Access Compliance Report

Public Rights-of-Way

Intersection ID: 29928	Main Street: BEARD_RD	Cross Street: CAROLINA_LILY_LN	Location: SE
ADA ID: C626CDAF8092	Ramp Type: BlendTrans1	Initial Pass/Fail: Fail	Overall Compliance: No
		Severity Score: 10

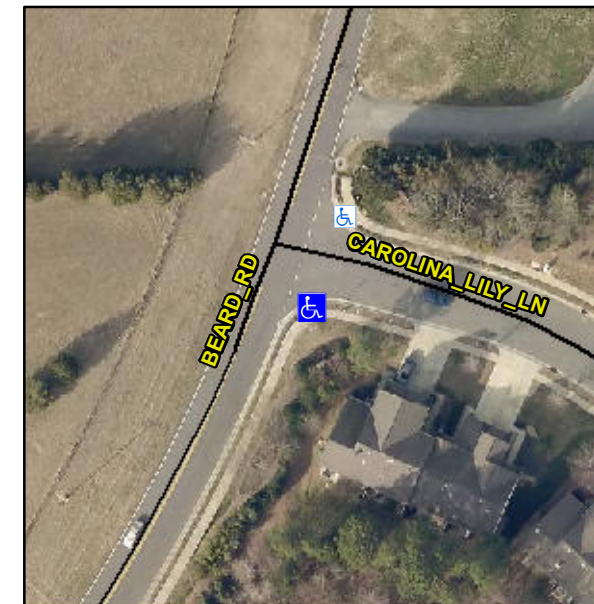
R304.5.1, R304.5.3

Compliance	Description	Data	Compliance	Description	Data
N/A	Ramp Length (in)	37.0	Yes	BlendTrans Slope (%)	3.5
No	Ramp Width (in)	43.0	No	BlendTrans XSlope (%)	4.4
N/A	Flare Type LT	N/A	N/A	Flare Type RT	N/A
N/A	Flare Slope LT (%)	N/A	N/A	Flare Slope RT (%)	N/A
N/A	Flare Traversable LT?	N/A	N/A	Flare Traversable RT?	N/A
N/A	Landing Length (in)	N/A	N/A	DWS Provided?	N/A
N/A	Landing Width (in)	N/A	N/A	DWS Contrast?	N/A
N/A	Landing Slope (%)	N/A	N/A	DWS Length (in)	N/A
N/A	Landing X Slope (%)	N/A	N/A	DWS Full Width?	N/A
N/A	Landing Curb? (Y/N)	N/A	N/A	DWS Offset (in)	N/A
N/A	Shared Landing?	N/A			
N/A	Gutter Ponding?	N/A	N/A	Gutter Slope (%)	N/A
N/A	Gutter Lip Ht (in)	N/A	N/A	Gutter X Slope (%)	N/A
N/A	Painted X Walk1?	No	N/A	Painted X Walk2?	N/A
	X Walk 1 Direction	To NE		X Walk 2 Direction	N/A
	X Walk 1 Width (in)	N/A		X Walk 2 Width (in)	N/A
	X Walk 1 Slope (%)	0.8		X Walk 2 Slope (%)	N/A
	X Walk 1 X Slope (%)	2.3		X Walk 2 X Slope (%)	N/A

N/A	Ramp inside XWalk1?	N/A	N/A	Ramp inside XWalk2?	N/A
	Road Slope (%)	2.3		Clear Space?	N/A
	Road X Slope (%)	0.8	N/A	Clear Space to XWalk (in)	N/A
N/A	Any Obstructions?	N/A	N/A	Storm Grate/Utility Hazard?	N/A
	Obstruction Type			Storm Grate/Utility Type	
		N/A			N/A
			Yes	Surface Condition? (G/P)	Good
			N/A	Curb Slope (%)	2.2

Remove & Replace Curb Ramp With Two New Directional Ramps or Equivalent.
